245 KV CURRENT TRANSFORMER TYPE: IMB 245 (31mm/kV)

CLIENT:
APTRANSCO

Revision		245 kV OUTDOOR CURRENT TRANSFORMER TYPE IMB 245	GENERAL ARRANGEMENT DRAWING (Small Tank)	Prepared: SR	Checked: SNP	Approved: SN	file: 3586-002	Total sh. 1
A	2022-11-14			HITACHI ENERGY INDIA LIMITED (FORMERLY KNOWN AS APPSIL)			1HYT903586-002	Sh.No. 1

CLIENT: ULTRATECH CEMENT LTD
END CUSTOMER: APTRANSCO
HITACHI ENERGY INDIA LIMITED WORKS ORDER NO:
4202222415/10
CLIENT WORK ORDER NO: AP/APG/7601063518
DTD. 31.10.2022
PROJECT:TADIPATRI PROJECT, AP

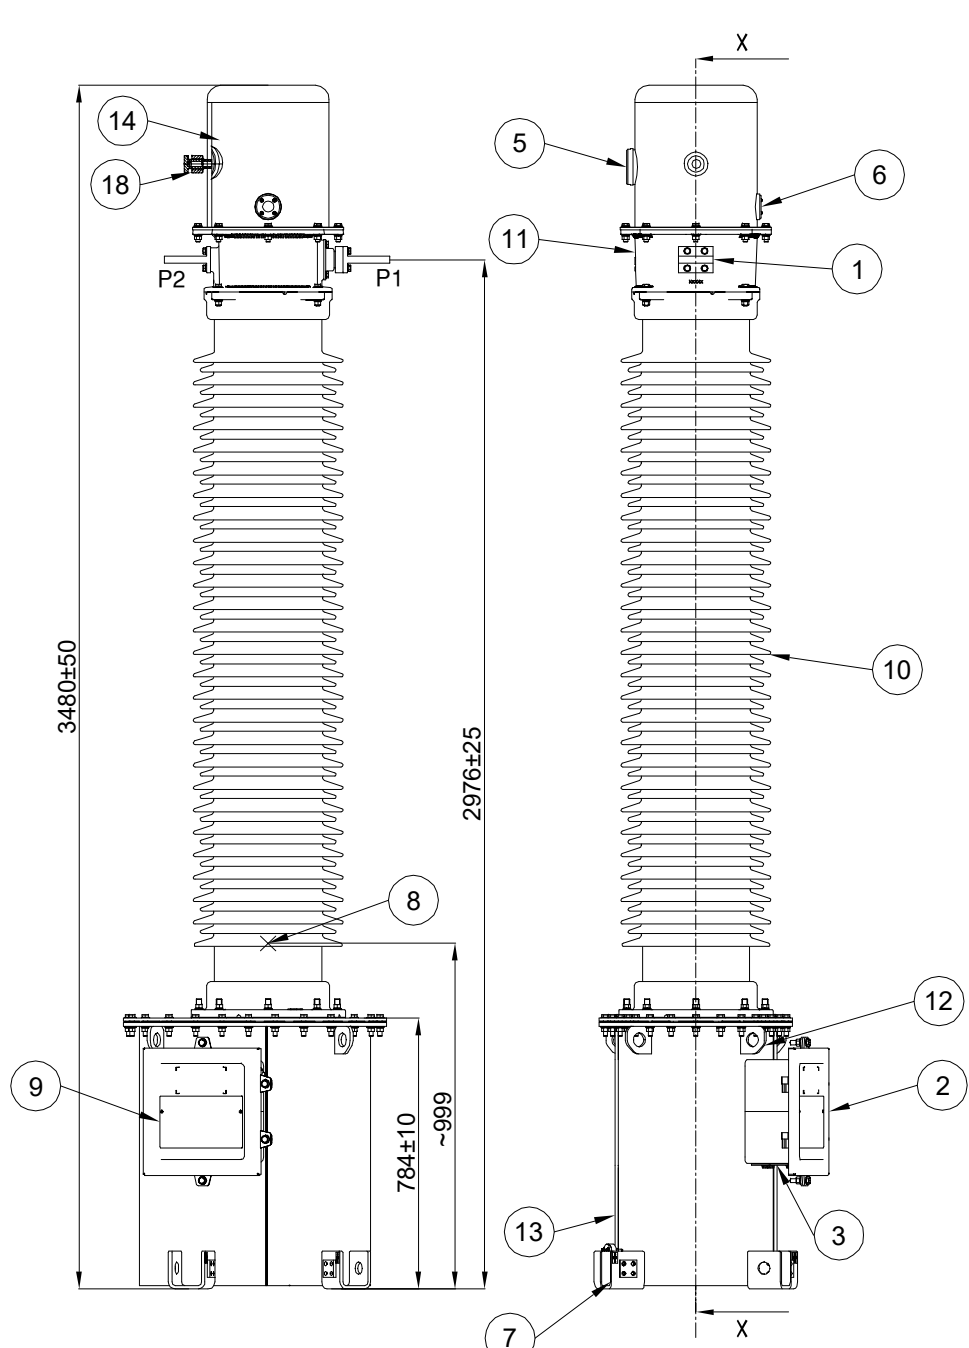
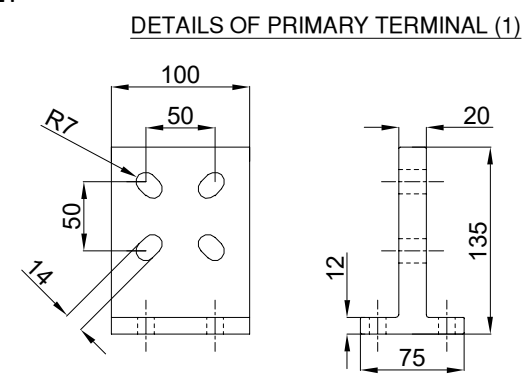
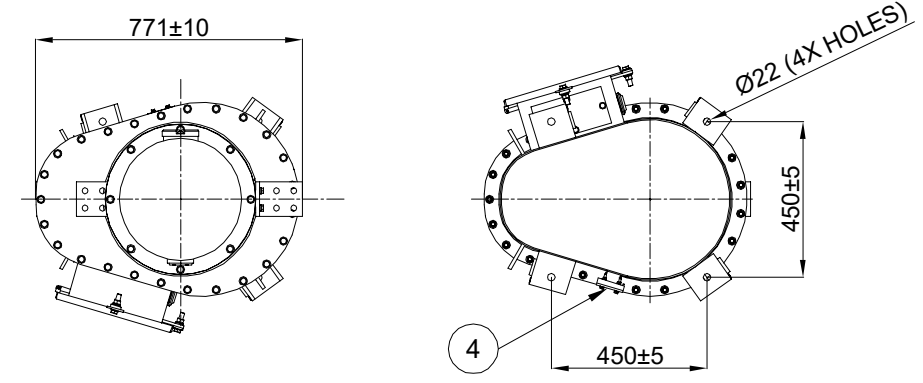
NOTE: 1. DRAWING APPROVAL SUBJECT TO VALID TYPE TEST REPORTS, TO BE CHECKED DURING ACCEPTANCE TESTS
2. FOR EPC CONTRACTS ONLY

Since the supply of terminal connectors is not in the scope of Manufacturer as mentioned in the drawings The EPC contractor shall be instructed to supply the same in line with CT/PT/CVT/Isolator/VT/LA/Breakers, requirement and capability.

1. Minimum 300mm plinth shall be maintained for CT/PT/CVT/ Isolators/IVT in the substation during foundation works to ensure Safe live to ground clearance as per IE rules.
2. since the supply of terminal connectors is not in the scope of Manufacturer as mentioned in the drawings. The EPC contractor shall be instructed to supply the same in line with CT/PT/CVT/Isolator /IVTs requirement and compatibility.

Revision		CURRENT TRANSFORMER		DRAWN:	CHECKED:	APPRD.:	file: 3586-004	TOTAL SH.
A	2022-11-14	TYPE : IMB 245		SR	PDS	SN		1
		SEC. TERMINAL BOX : DETAILS		HITACHI ENERGY INDIA LIMITED (FORMERLY KNOWN AS APPSIL)			1HYT903586-004	Sh. NO.
								1

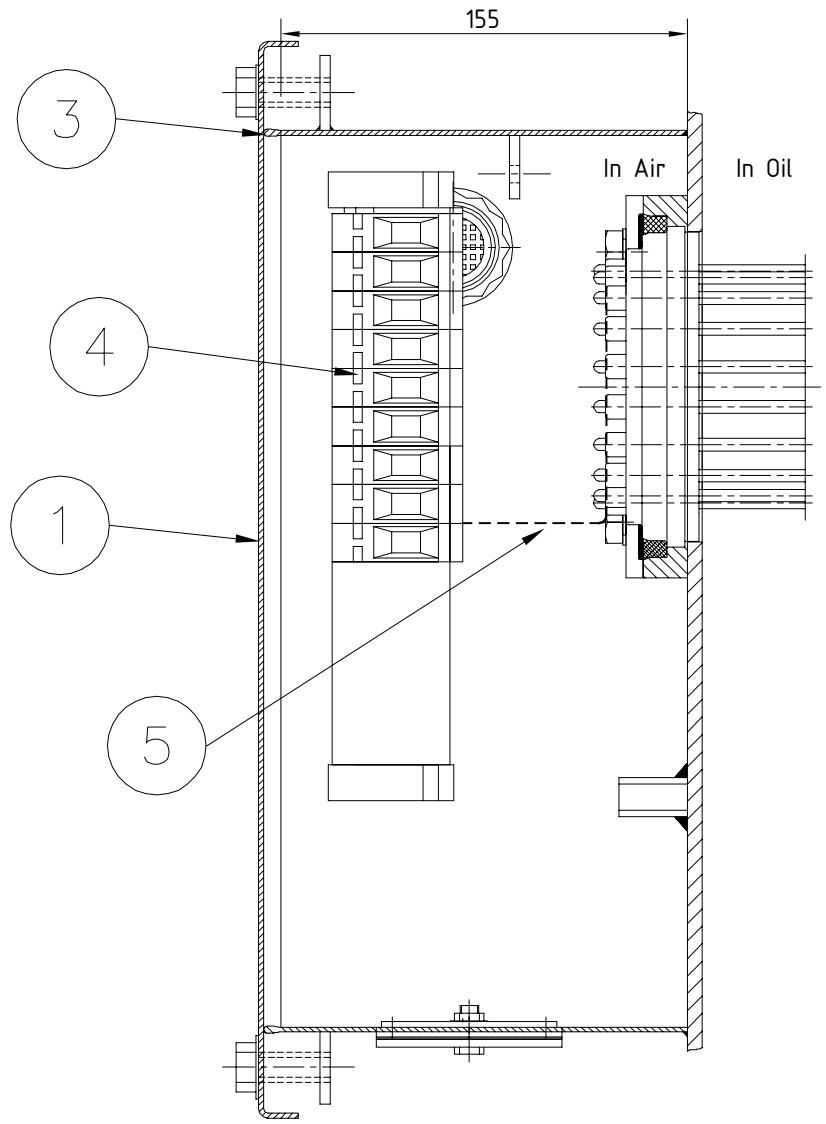
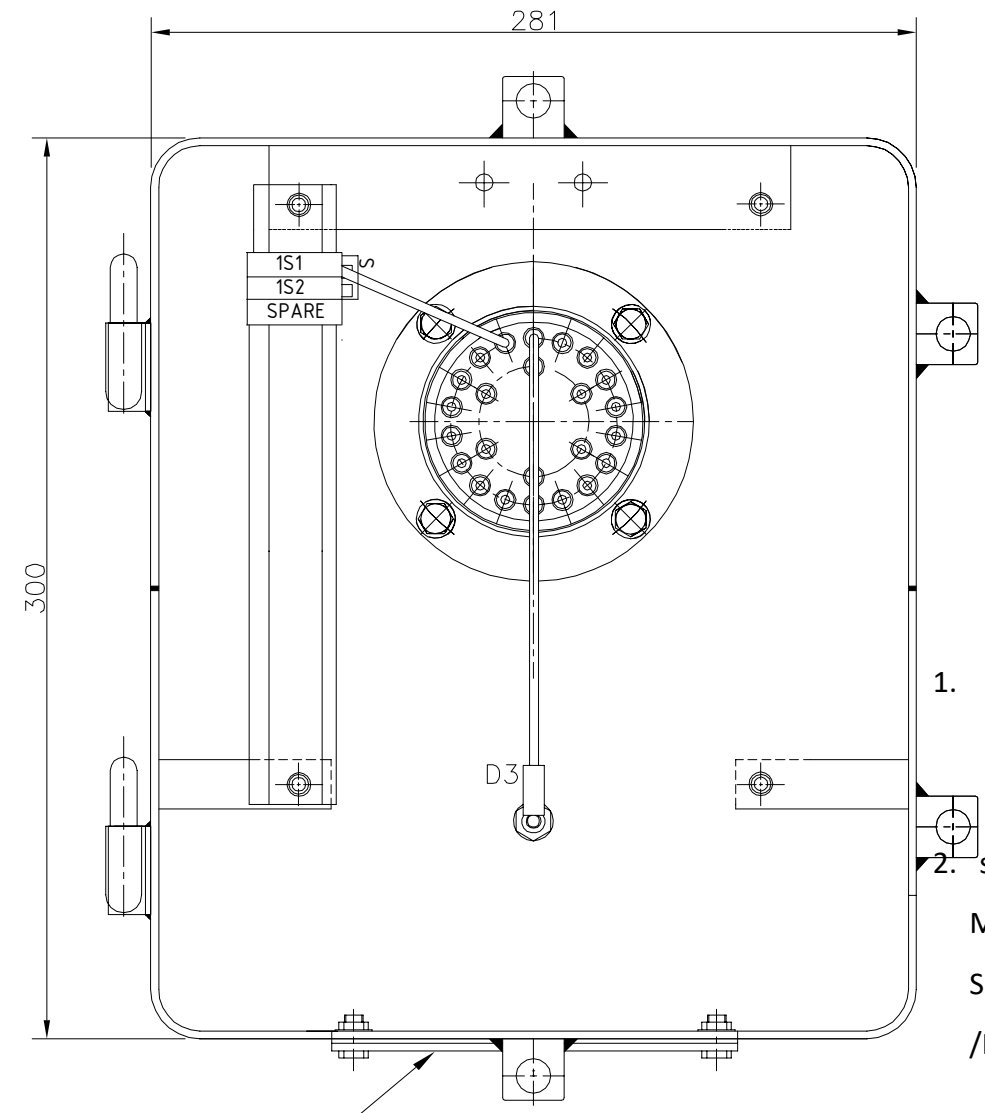
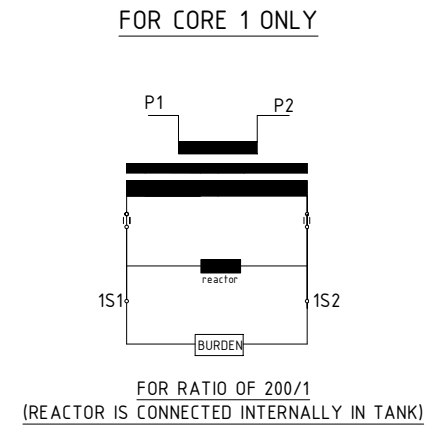
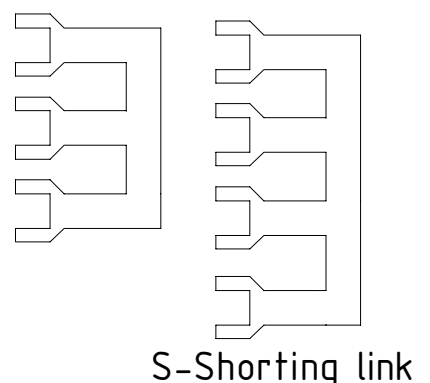
NOTE: 1. DRAWING APPROVAL SUBJECT TO VALID TYPE TEST REPORTS, TO BE CHECKED DURING ACCEPTANCE TESTS
2. FOR EPC CONTRACTS ONLY

1. Minimum 300mm plinth shall be maintained for CT/PT/CVT/ Isolators/IVT in the substation during foundation works to ensure Safe live to ground clearance as per IE rules.
2. since the supply of terminal connectors is not in the scope of Manufacturer as mentioned in the drawings. The EPC contractor Shall be instructed to supply the same in line with CT/PT/CVT/Isolator/IVTs requirement and compatibility.

Revision		245 kV OUTDOOR CURRENT TRANSFORMER TYPE IMB 245	INSULATOR DRAWING	Prepared: SR	Checked: PDS	Approved: SN	file: 3586-005	Total sh.
A	2022-12-12			ABB HITACHI ENERGY INDIA LIMITED (FORMERLY KNOWN AS APPSIL)			1HYT903586-005	Sh.No. 1

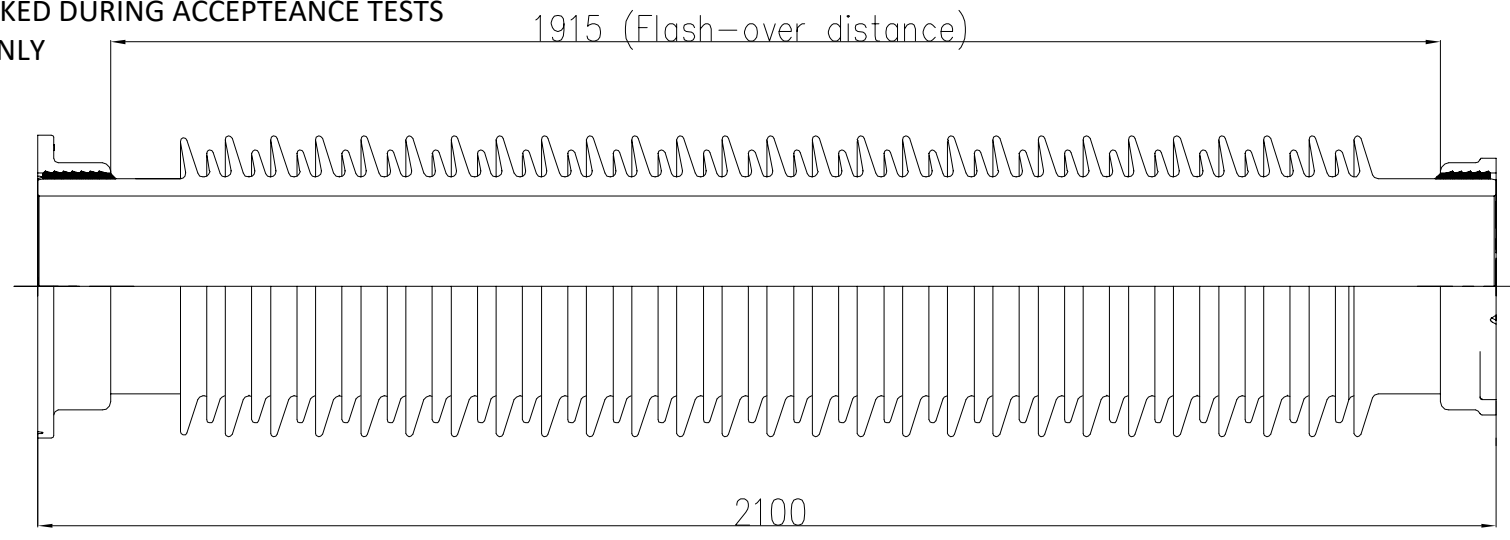
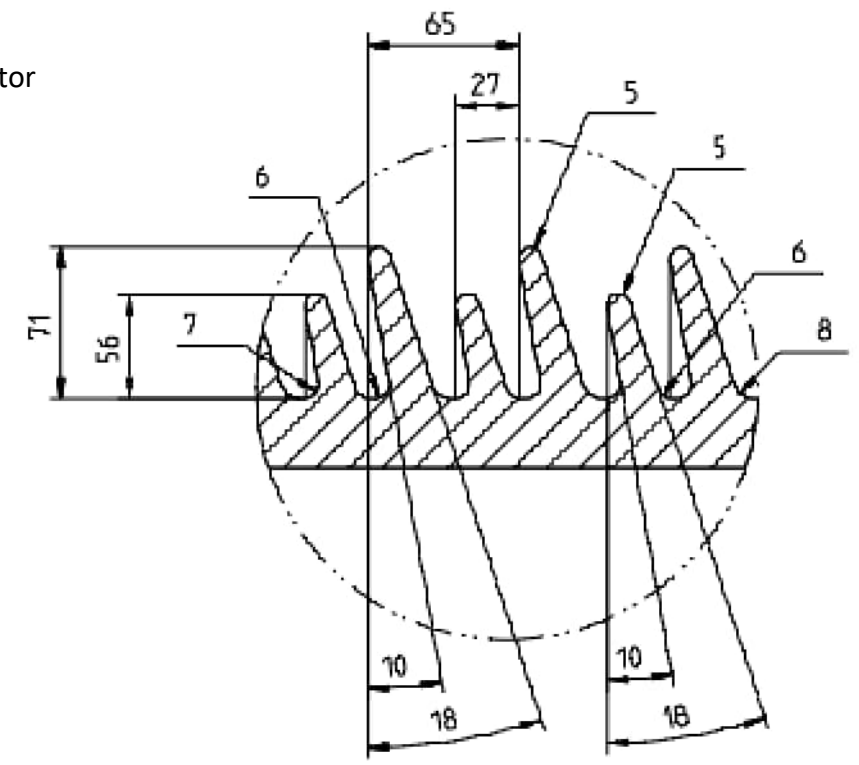
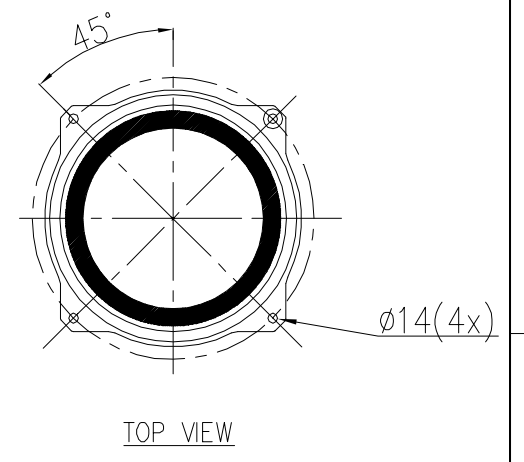
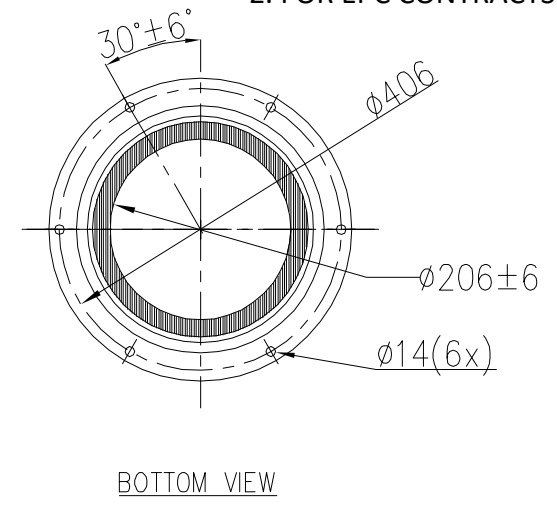
NOTE: 1. DRAWING APPROVAL SUBJECT TO VALID TYPE TEST REPORTS, TO BE CHECKED DURING ACCEPTANCE TESTS
2. FOR EPC CONTRACTS ONLY

1. Minimum 300mm plinth shall be maintained for CT/PT/CVT/ Isolators/IVT in the substation during foundation works to ensure Safe live to ground clearance as per IE rules.
2. since the supply of terminal connectors is not in the scope of Manufacturer as mentioned in the drawings. The EPC contractor Shall be instructed to supply the same in line with CT/PT/CVT/Isolator /IVTs requirement and compatibility.
